Detailed Site Plan
Departure from Design Standards
Alternative Compliance
Hampton Park

DSP-16052-03
DDS-676
AC-17005-01

STAFF REPORT

SUBJECT: Detailed Site Plan DSP-16052-03
Departure from Design Standards DDS-676
Alternative Compliance AC-17005-01
Hampton Park

Figure 3: Sign Elevations

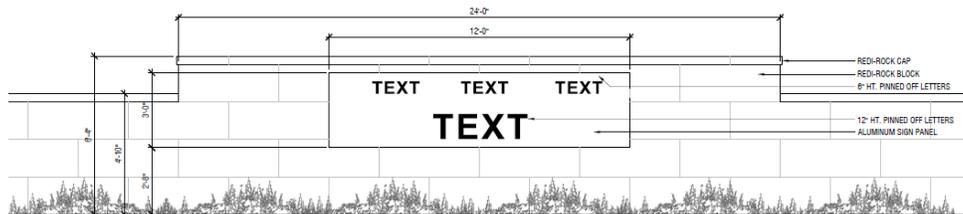
- l. Provide sign details showing the size, material, color, and illumination to be consistent with other signs in the development.
 - m. Clearly label and delineate the dog park on the site and landscape plans.

LAYOUT PLAN - COURTYARD

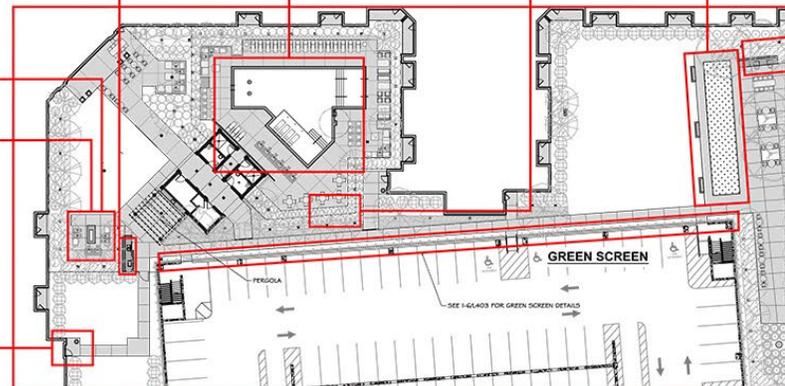
- f. Provide additional noise mitigation techniques in the dog park to reduce noise to acceptable levels and provide a detail for the fence.
 - g. Identify on the DSP which sections of the building facades require architectural treatment for noise mitigation.
